# Bulletin Number - BP4C KVC - 02

<b>Project</b>	Steamboat Base Village Redevelopment	<b>Date</b>	12/13/2021
<b>Project Location</b>	Steamboat, Colorado	<b>Architect's Project Number</b>	03.7835.000
<b>Owner/Client</b>	Alterra Mountain Company / East West Partners	<b>File</b>	6BL <b>This is page</b> 1 of 2
<b>To</b>	Saunders Construction Inc.	<b>Attention</b>	Bryan Sculthorpe
<b>Address</b>	86 Inverness Place North		
<b>City</b>	Englewood	<b>State</b>	CO <b>Zip Code</b> 80112
<b>Delivered via:</b>	<input type="checkbox"/> <b>Messenger</b> <input type="checkbox"/> <b>Hand carried</b> <input type="checkbox"/> <b>Facsimile</b> <input type="checkbox"/> <b>Express</b> <input type="checkbox"/> <b>Pick-up</b> <input type="checkbox"/> <b>E-mail Address</b> <input type="checkbox"/> <b>Mail</b> <input type="checkbox"/> <b>UPS</b> <input checked="" type="checkbox"/> <b>Website Address</b> BIM360

### Description of Changes

- Updated MEP and arch roof plan
- Updated steel reinforcing for roof (sketch)

Project Name  
**Steamboat Base Village Redevelopment**  
Project Number  
**003.7835.000**  
Description  
**MECHANICAL PLAN - LEVEL 01**

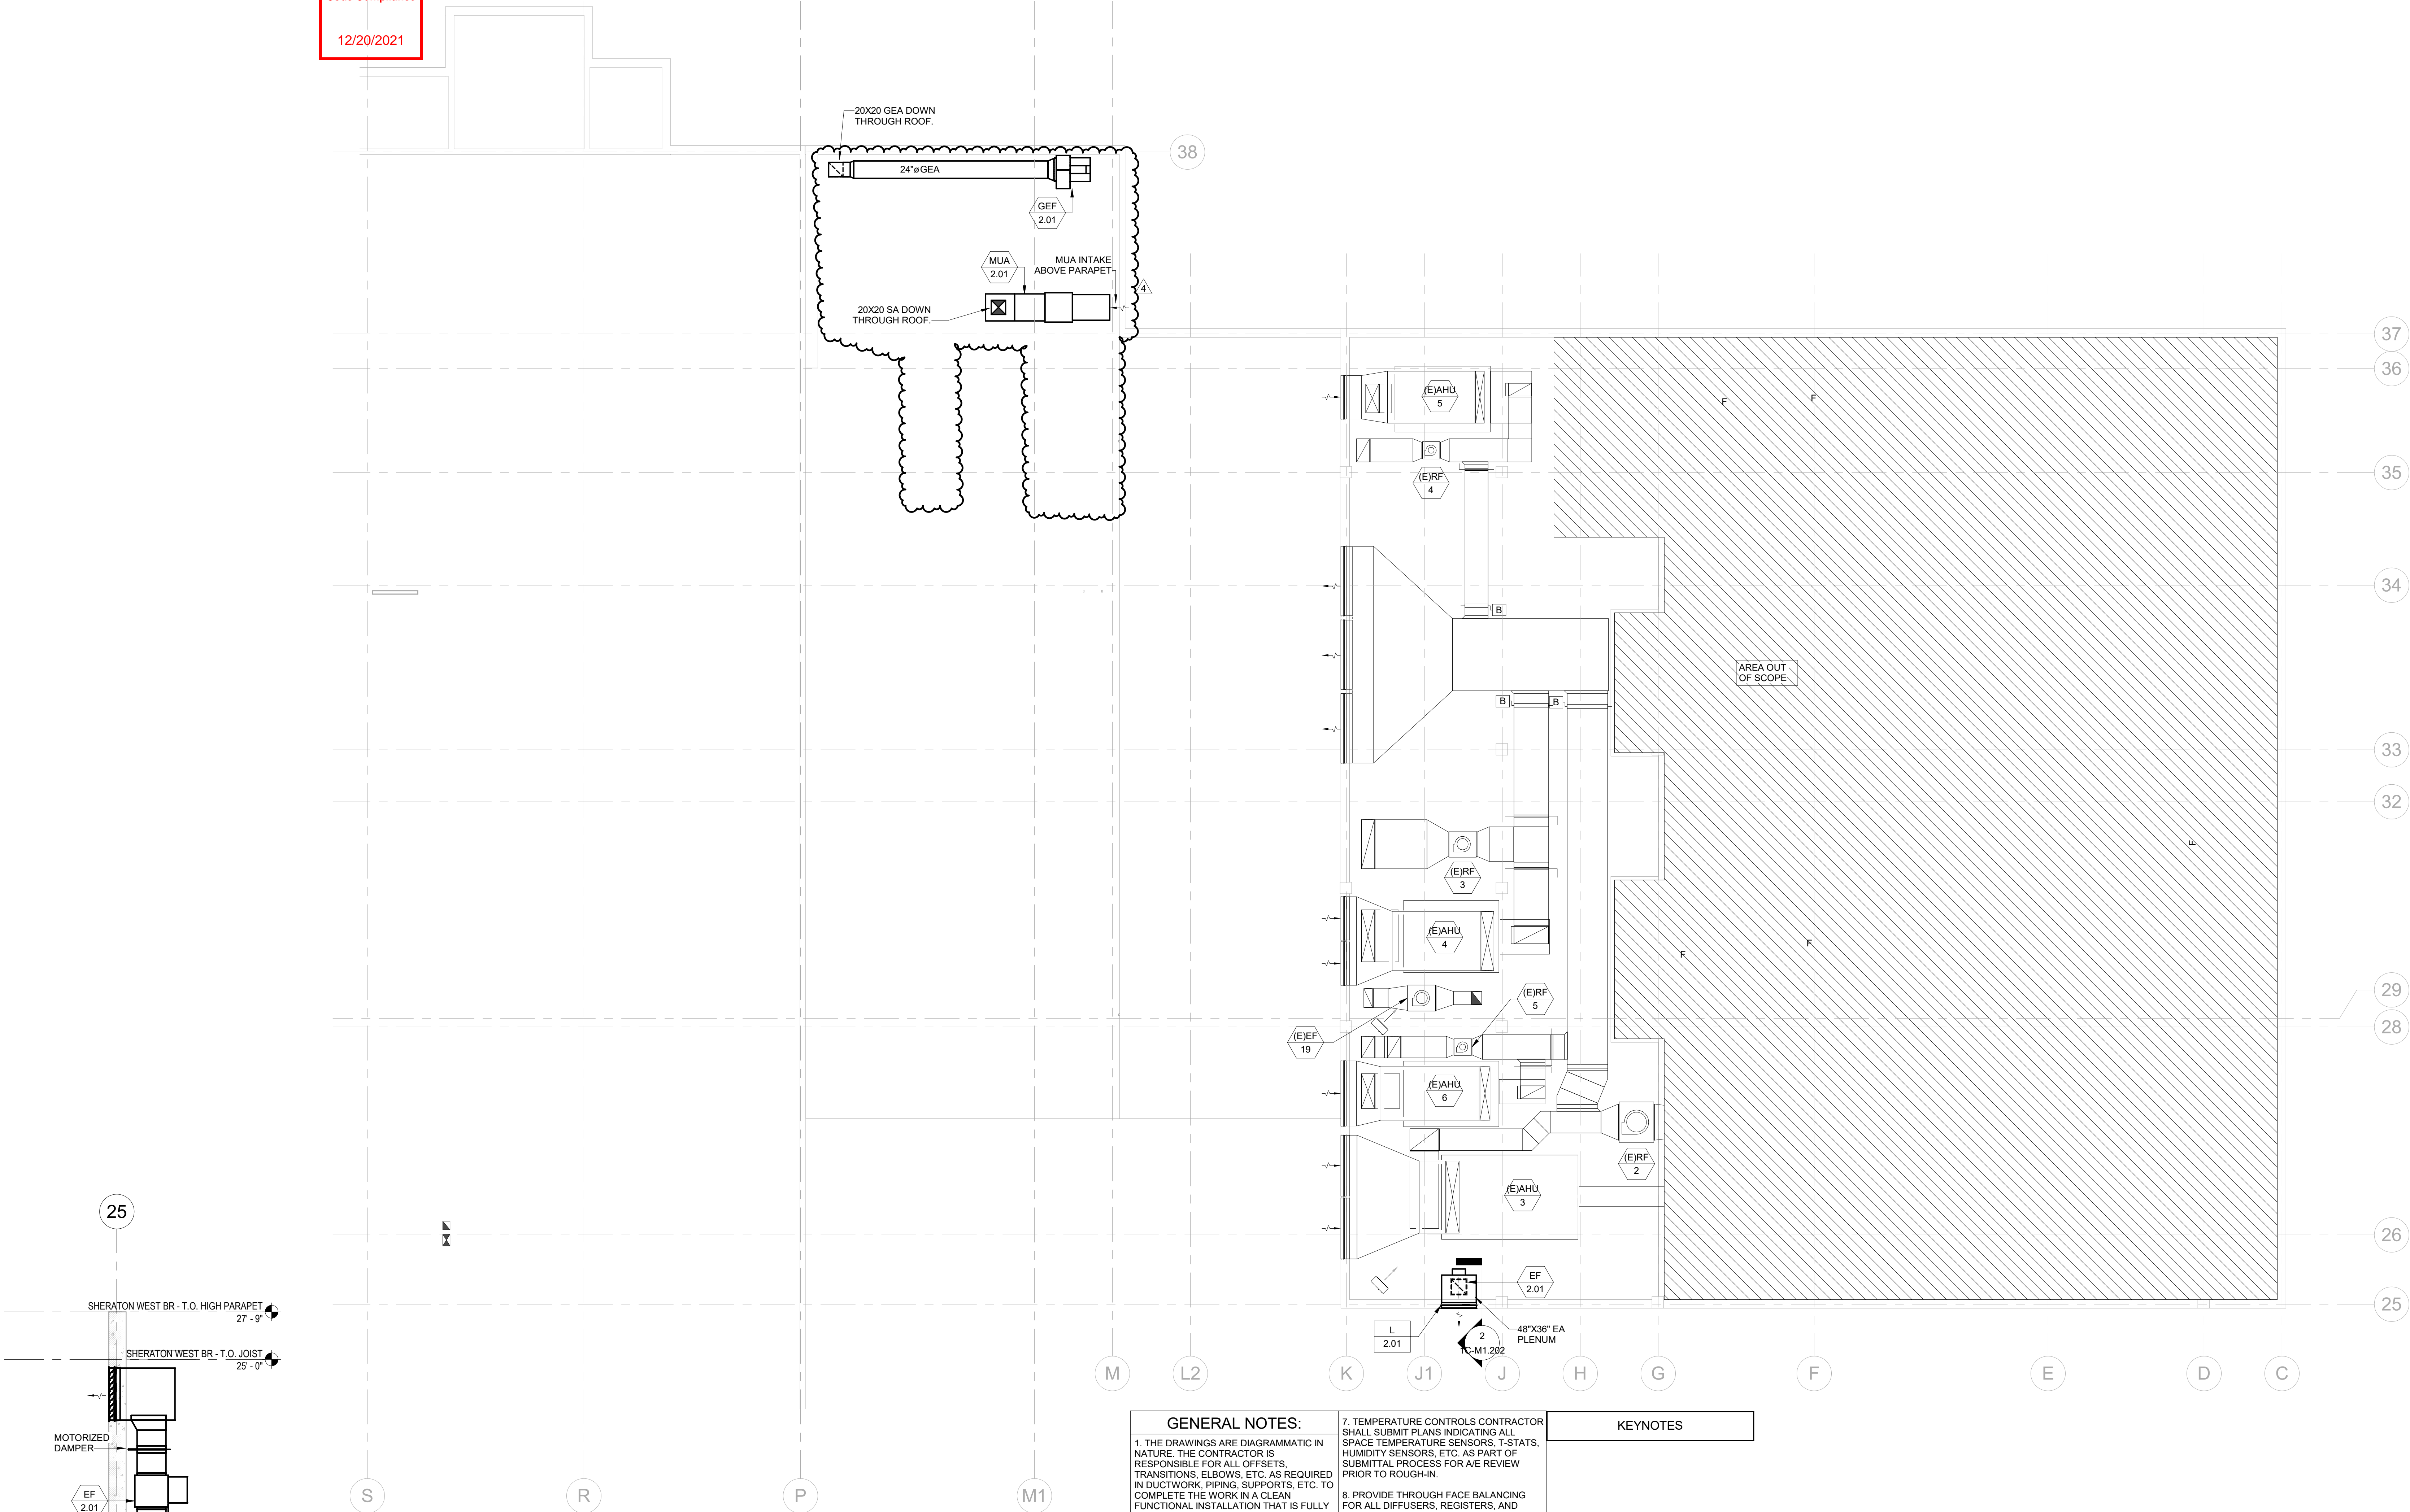
- 1C-DM1-101
  - Revised demolition scope
- 1C-M1.201
  - Relocated walk-in cooler condensing unit to grade level outside building.
  - Revised sheet metal layout in kitchen to accommodate existing hydronic piping mains.
- 1C-M1.202
  - Relocated grease exhaust fan and makeup air unit on roof. Relocated food service condensing units to grade level outside building.
- 1C-M8.001
  - Added detail for sheet metal around existing hydronic piping mains.
